BUC-EE'S #87 EL PASO COUNTY, CO
ISSUED FOR CITY SUBMITTAL
EL PASO COUNTY, CO
BUC-EE'S LTD.

DATE:	SUBMITTAL:	DESCRIPTION (SHEETS / SPECS):
2026-09-10	CITY SUBMITTAL	L000, L100, L101, L102, L103, L104, L105, L106, L107, L108, L109, L110, L111

V1_Landscape Plan drawings.pdf Markup Summary

SHEET NO.:
L100

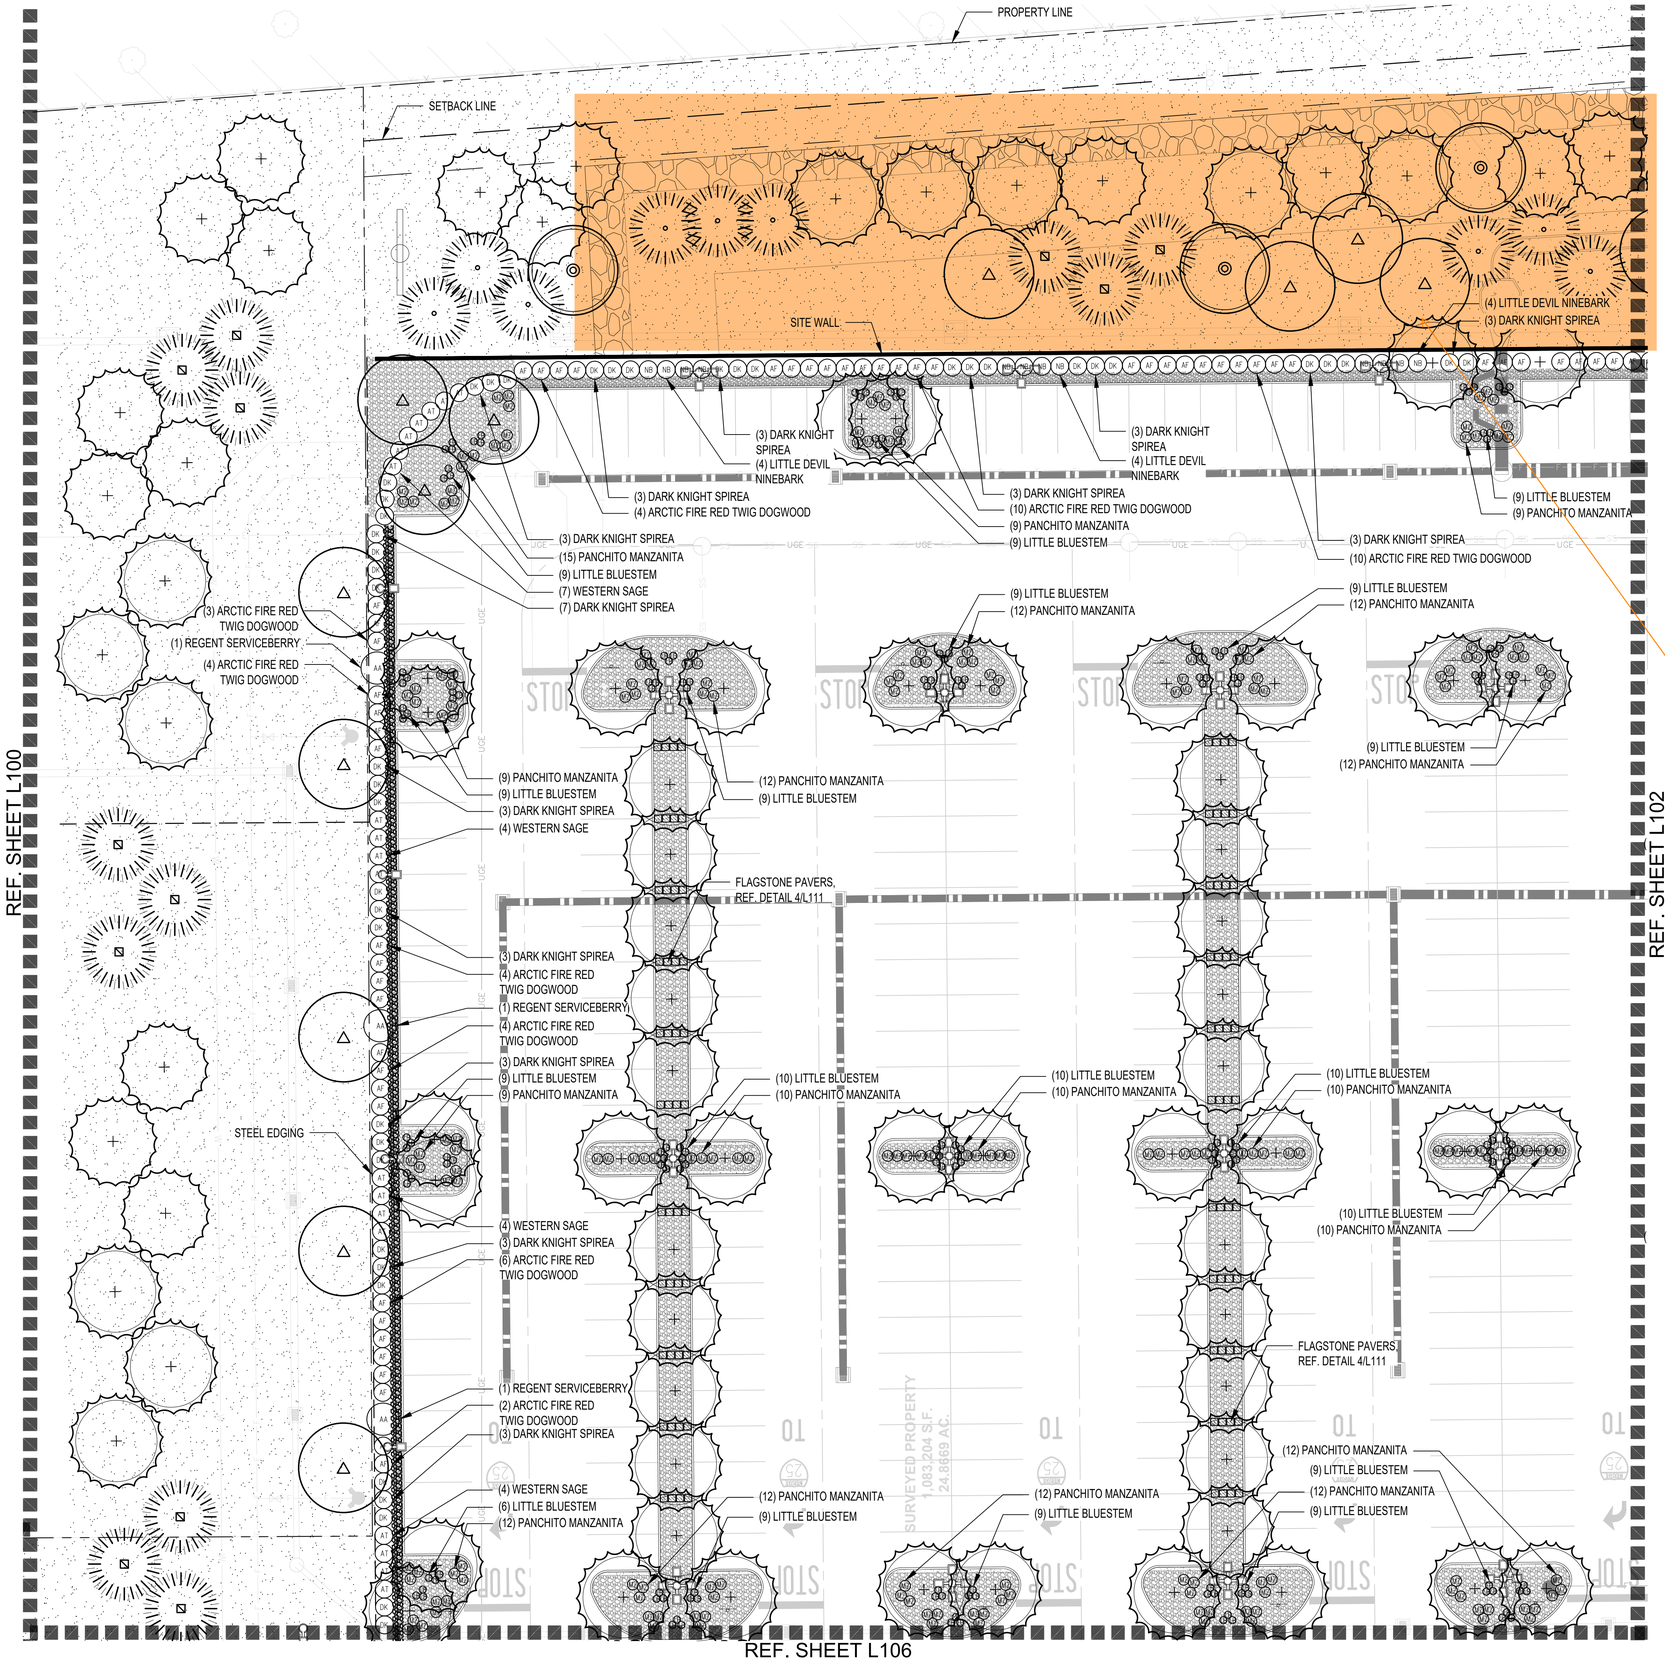
Can you depict which plantings count towards roadway landscaping, internal landscaping and parking lot landscaping?

Water Storage Tank and Utility Facilities Landscape Requirements. (i)Site-Specific Landscaping Required. PCD Director approval of site-specific landscaping is required for a water storage tank and utility facilities. Installation of approved site-specific landscaping is required prior to putting a water storage tank or utility facility into operation. The site-specific landscaping is subject to the following standards:

- Rural and Remote Areas: In rural and remote areas landscaping, screening and erosion control measures shall be tailored to the nature and character of the area and the type of facility or structure contemplated. Site-specific landscaping shall, at a minimum, include revegetation of disturbed areas with materials indigenous to the site or otherwise adaptable.

- Urbanized and Developed Areas: In urbanized and developed areas, the site-specific landscaping shall address specific issues such as screening and visual impacts

this is classified as a rural major collector

Is this grouping of plants counting towards your roadway landscaping? If so, they are exceeding the requirement that says roadway landscaping trees shall be located within 50ft of th road right-of-way.

Label the bike pavillion

Add placement of fire hydrants.

SHEET NO.:
L101

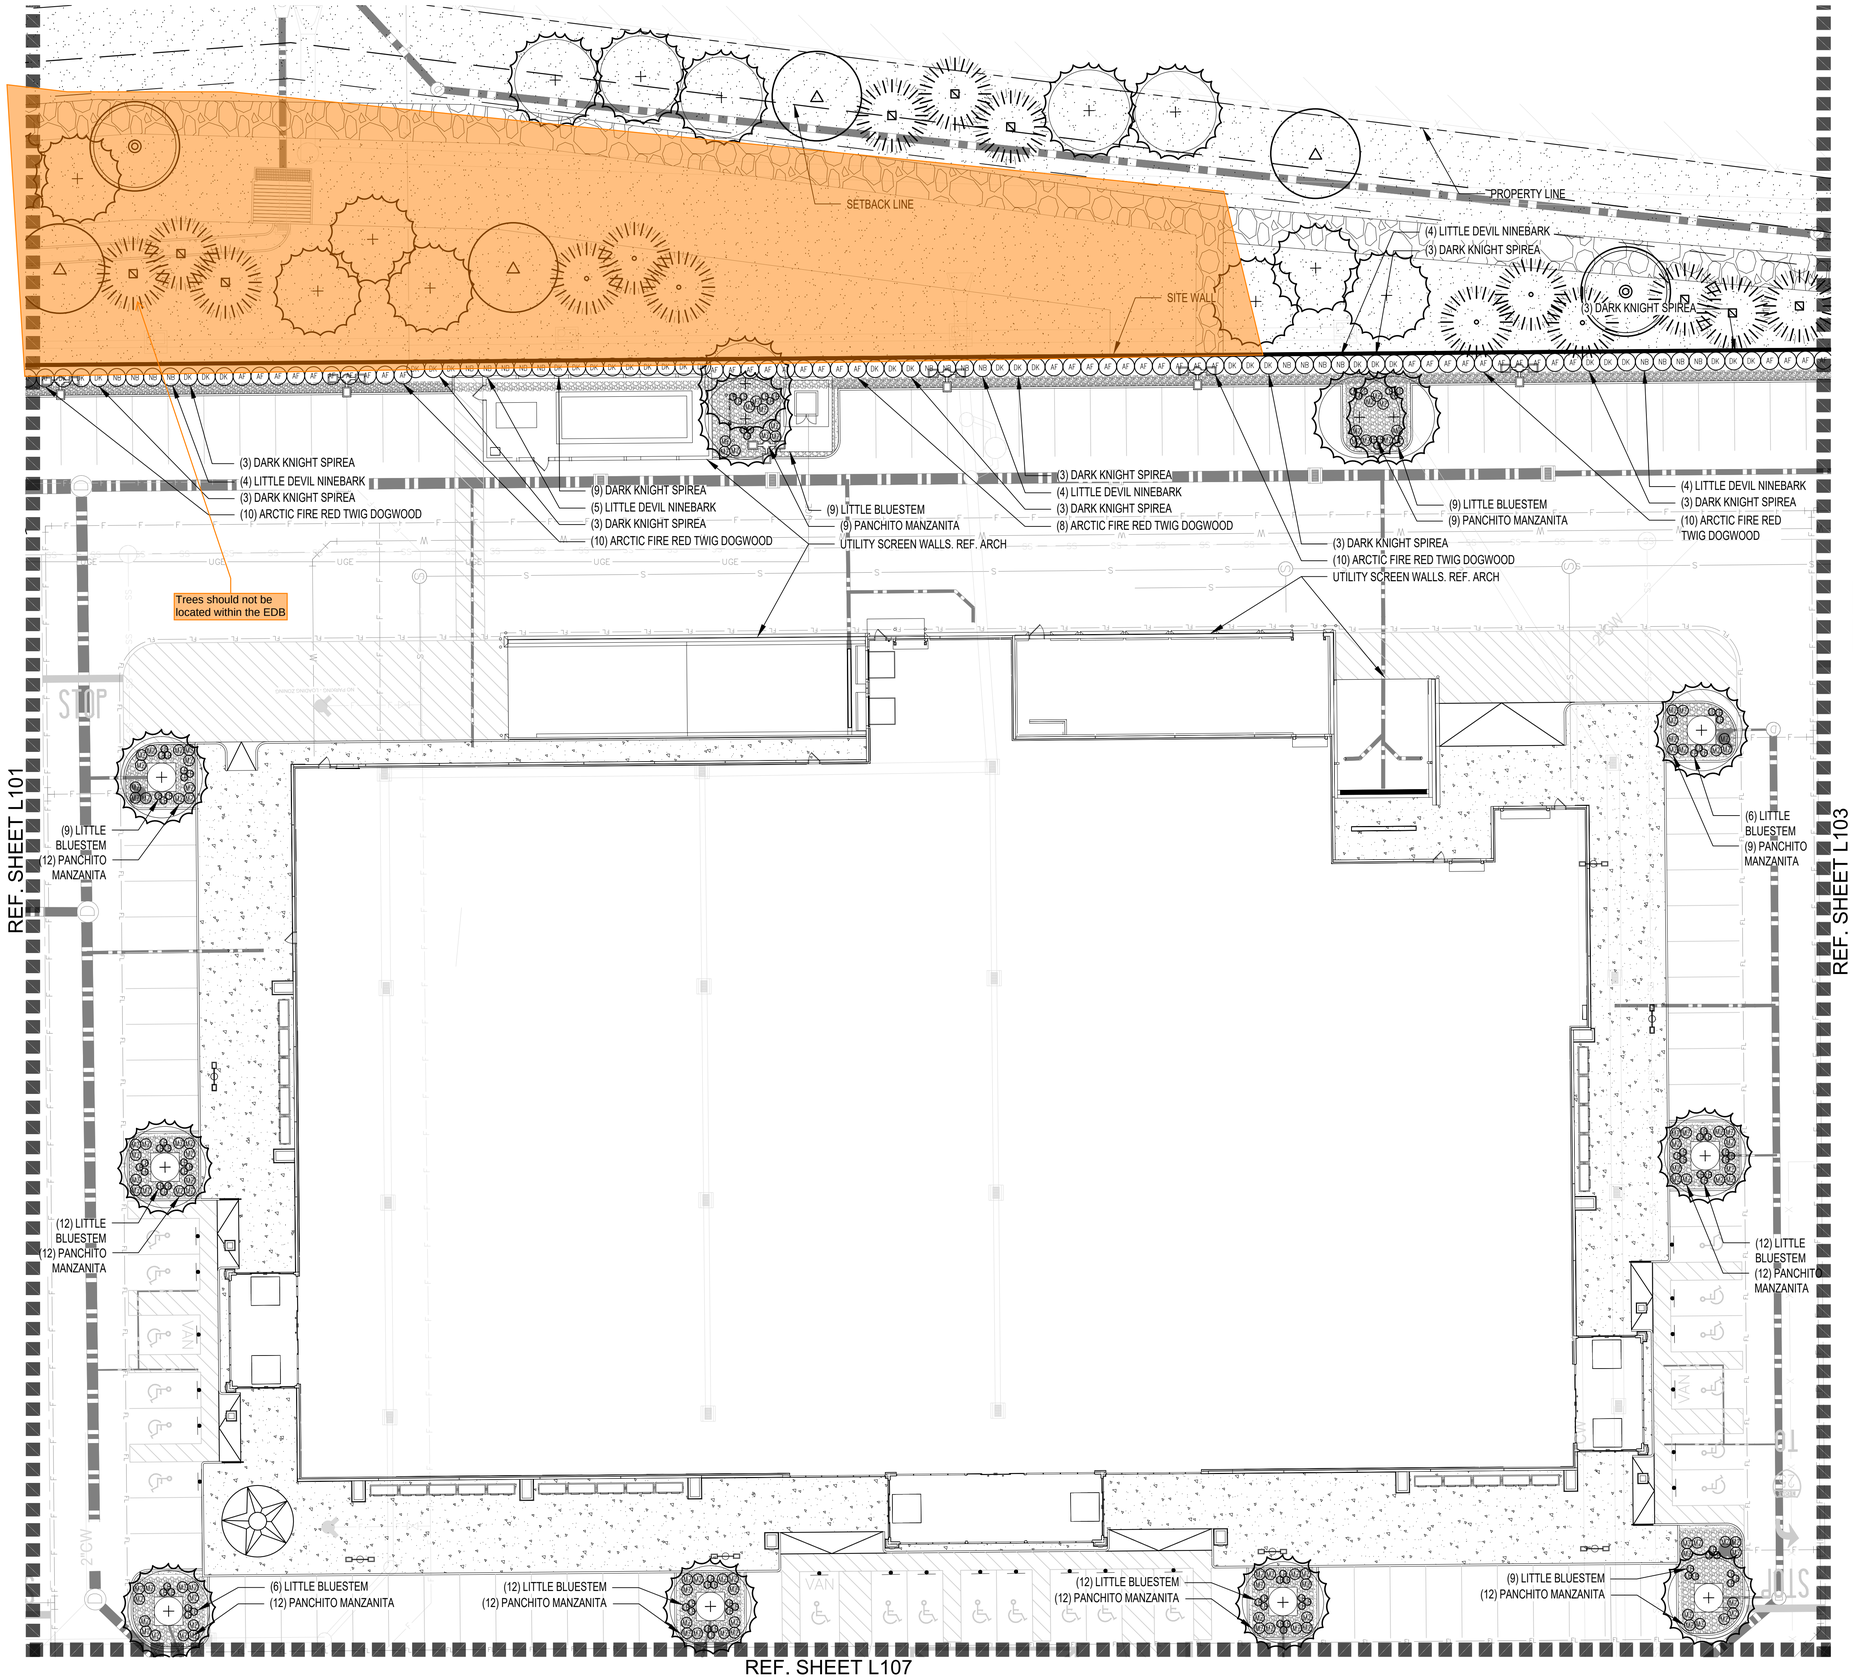
Trees should not be located within the EDB

SHEET NO.:
L107

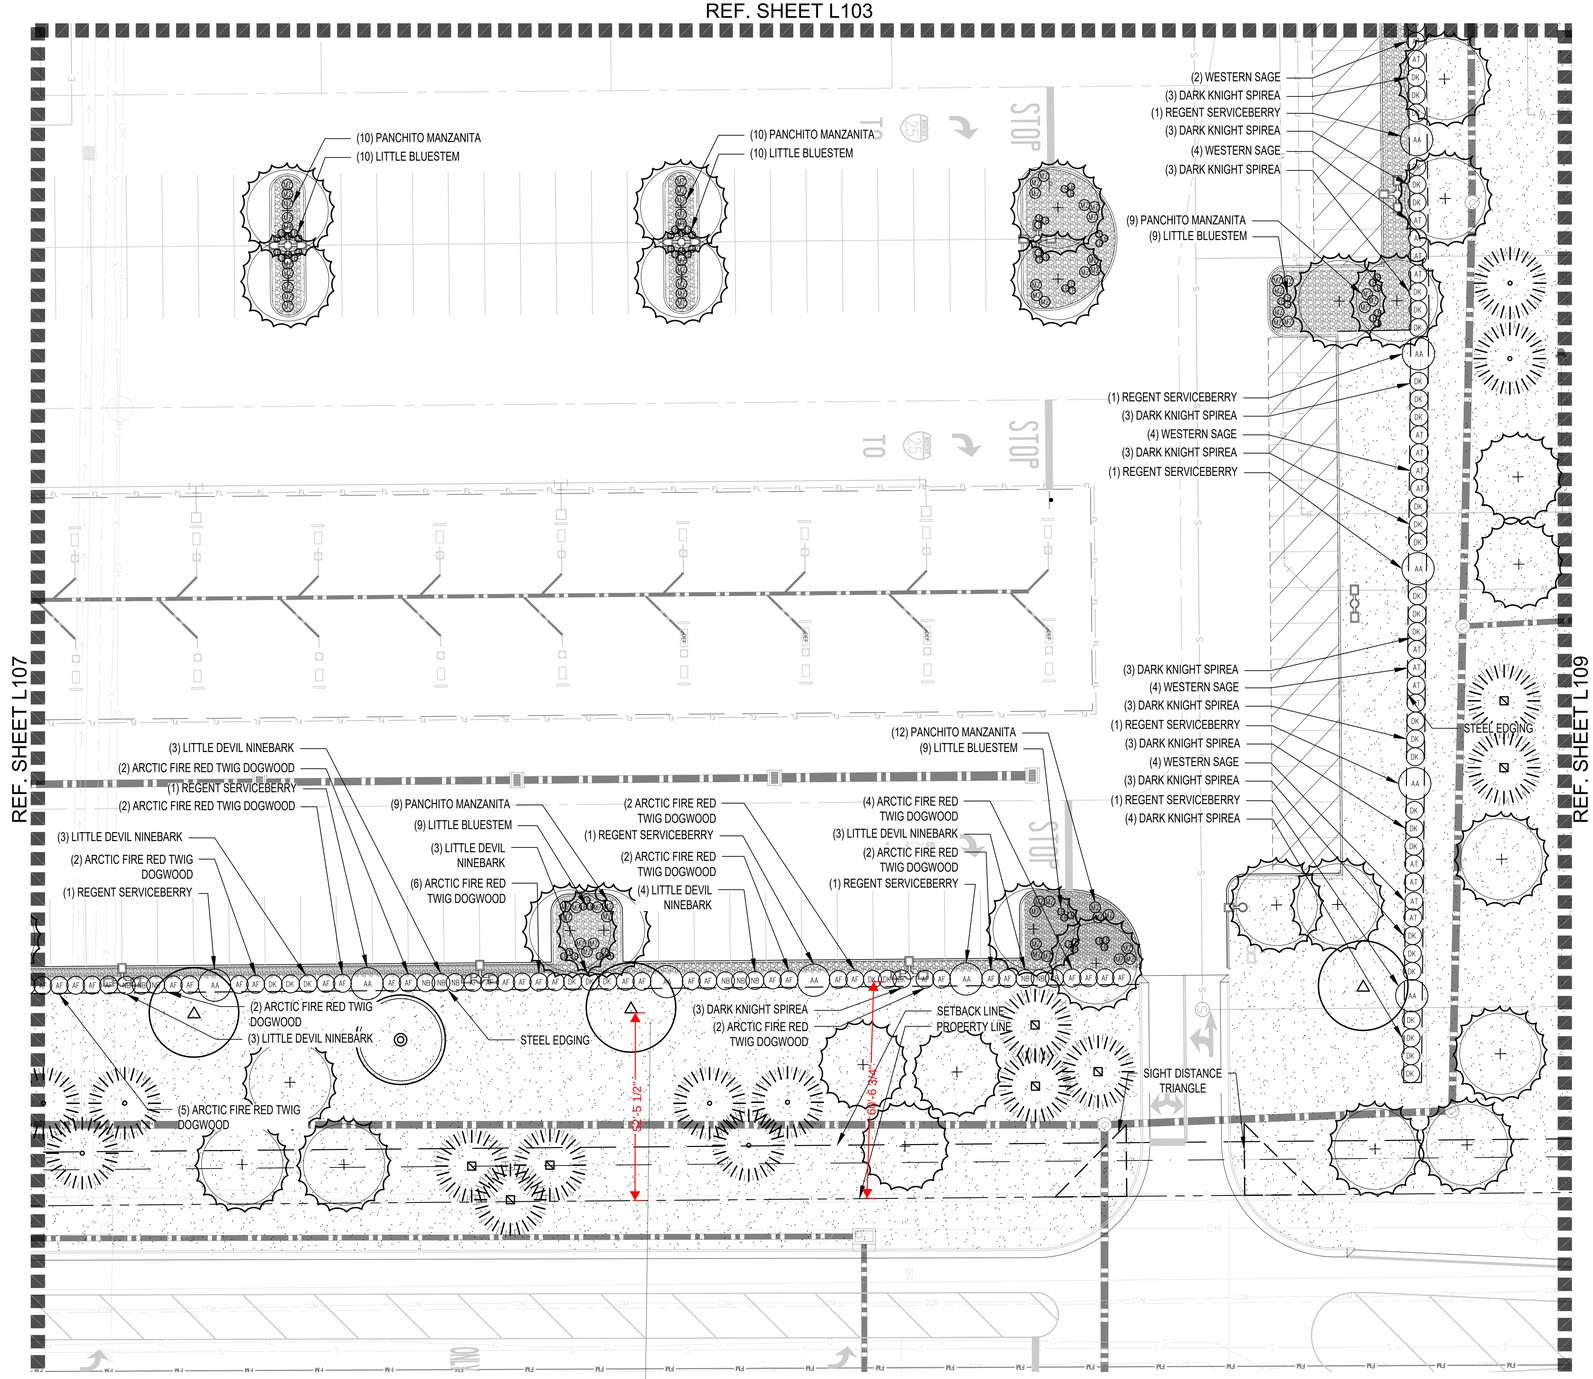
The roadway landscaping trees shall be located within 50 feet of the road right-of-way, easement or tract boundary line and any building or use.

There are several trees that exceed the 50' requirement from the right of way.

SHEET NO.:
L108

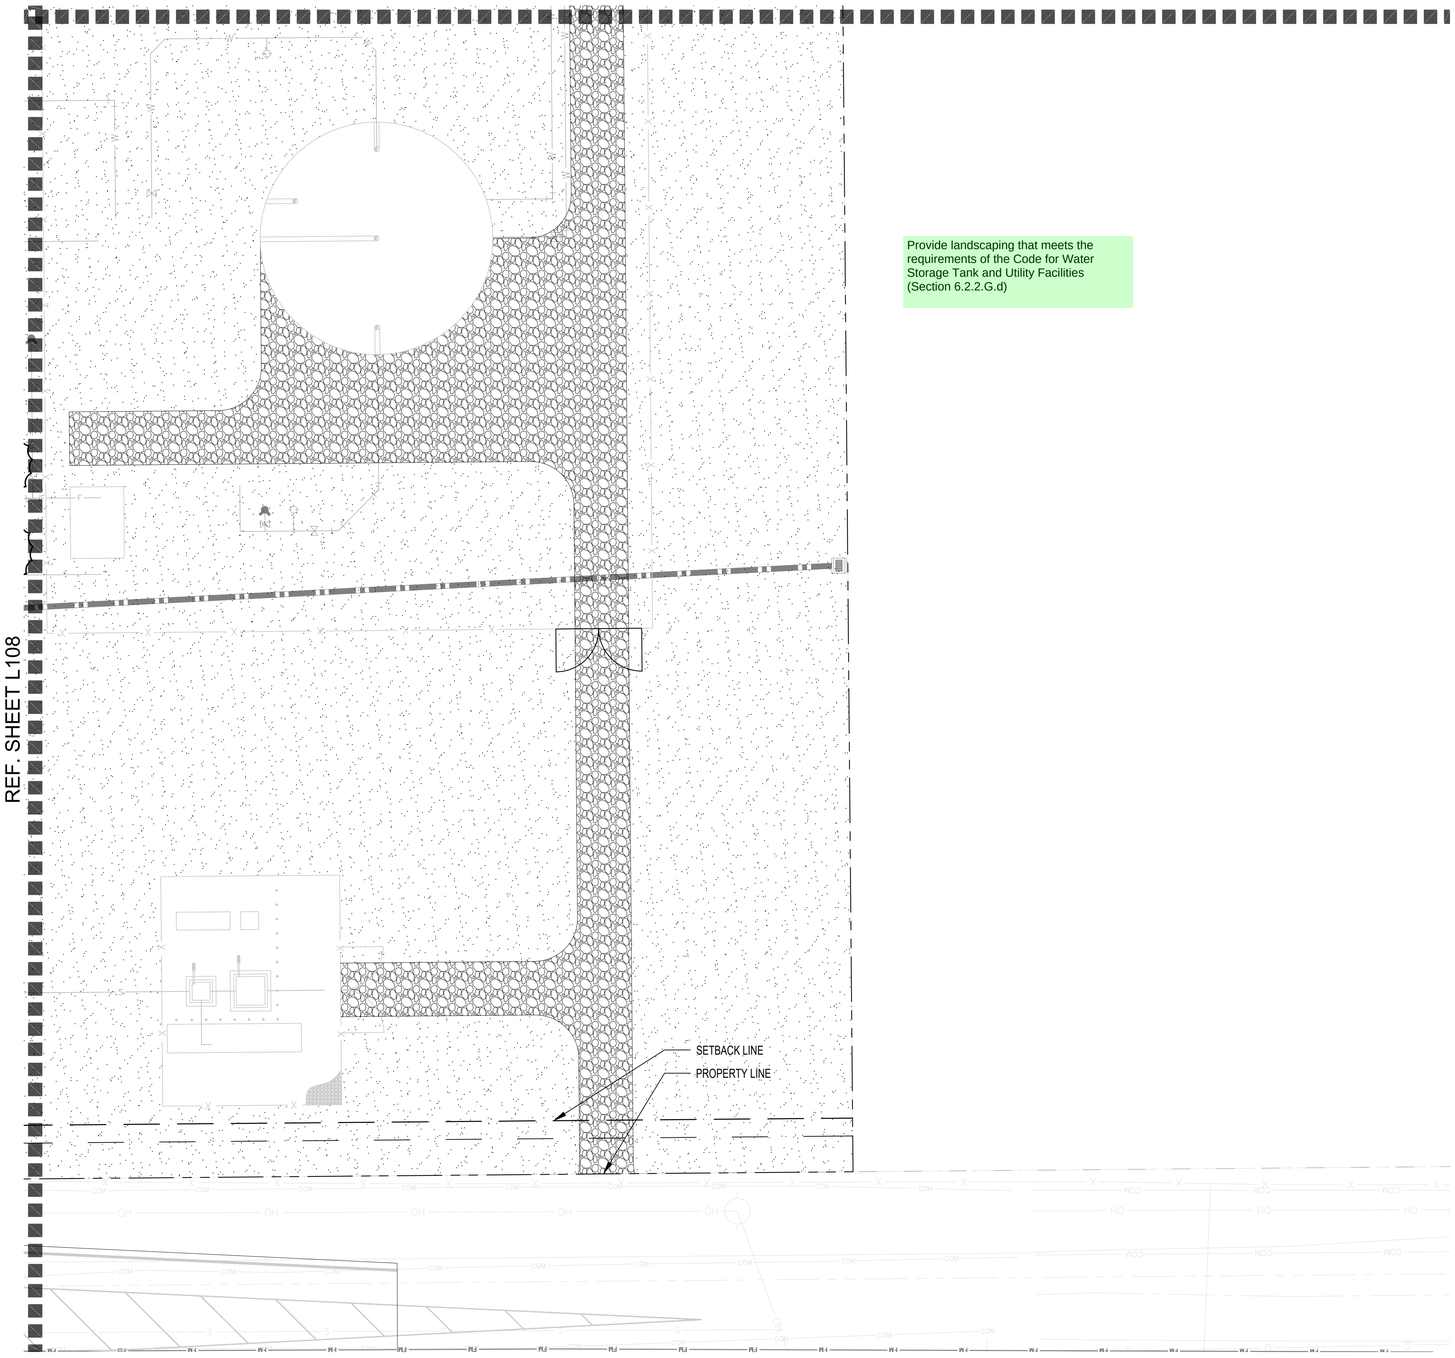
include seed mix with GEC Plans

Provide landscaping that meets the requirements of the Code for Water Storage Tank and Utility Facilities (Section 6.2.2.G.d)
